FINAL DRAINAGE LETTER FOR LOT 2 CLAREMONT BUSINESS PARK 2 FILING NO. 2 EL PASO COUNTY, COLORADO

PCD File # PPR2345

February 2023

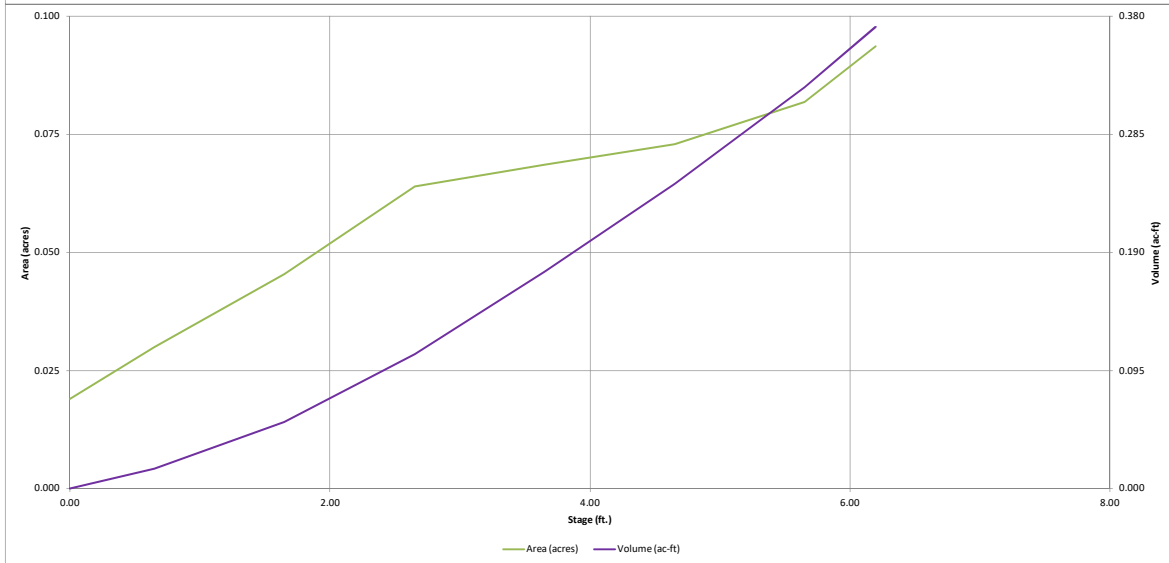
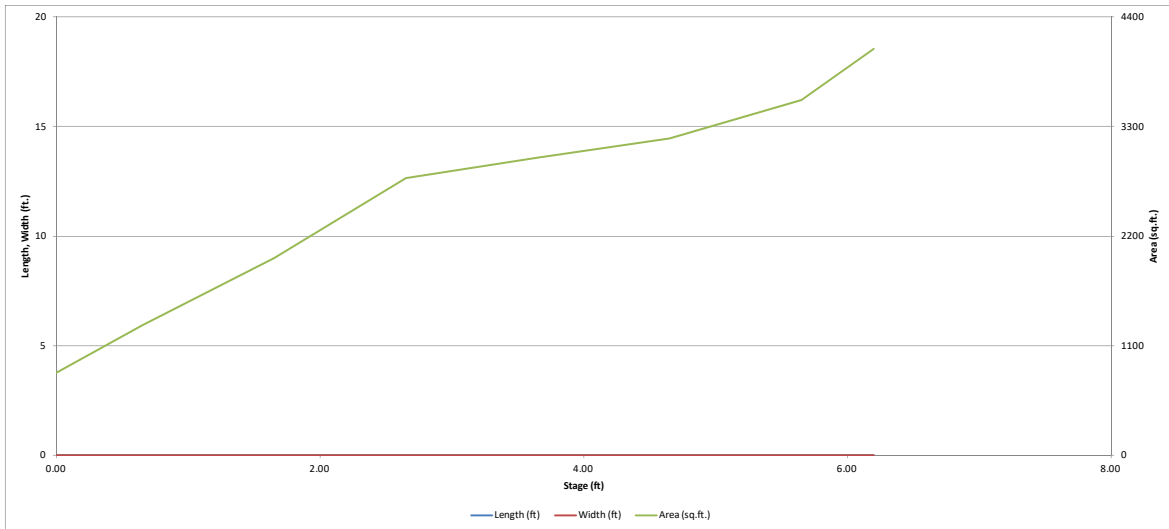
clarify that these calcs were previously reviewed/approved under V233, contrary to what the calc sheets say: "Pond 3 to be designed and constructed with this report."

WEST SWALE $Q_{100} = 0.2$ cfs

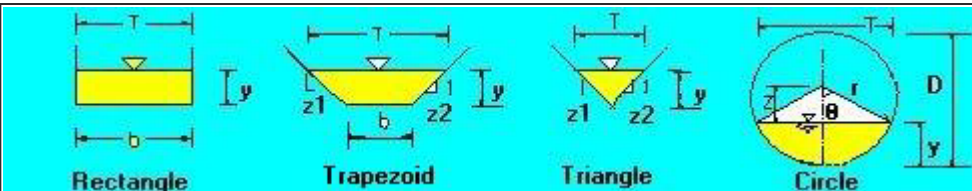
high vs .9

POND 3 SAND FILTER DETENTION BASIN DATA

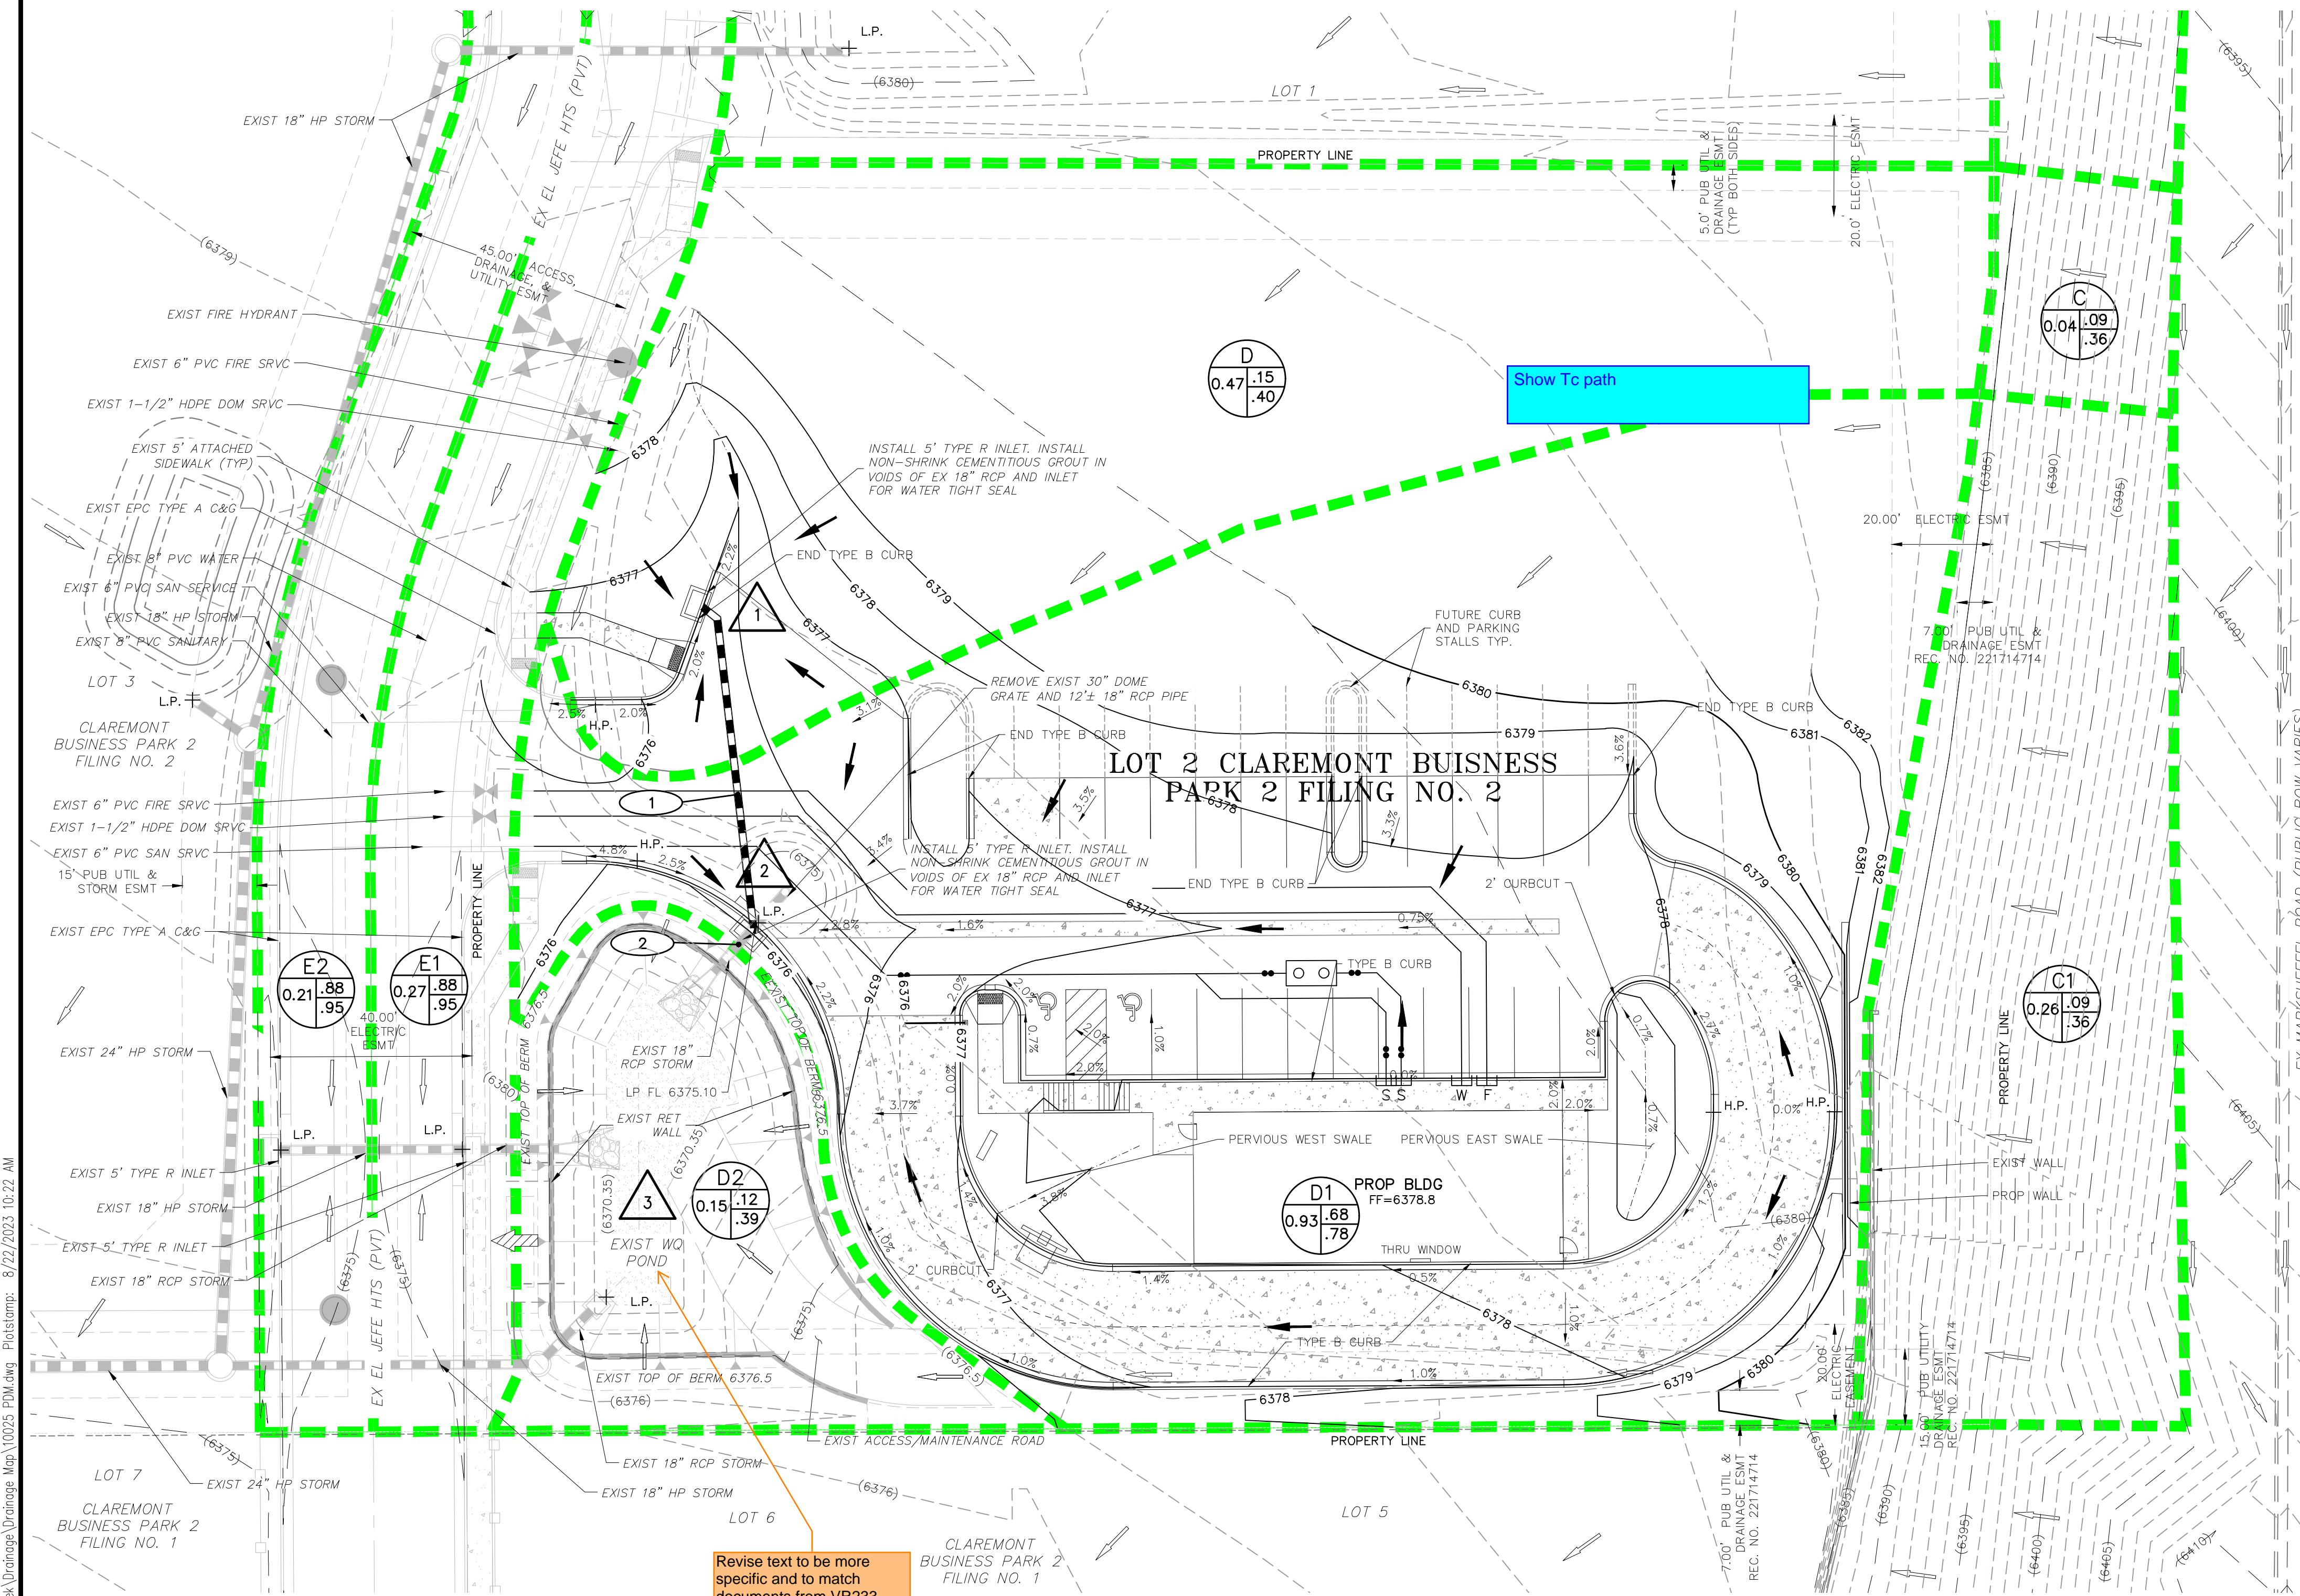
Revise text to be more specific and to match documents from VR233 - "WQ Sand Filter Pond 3"
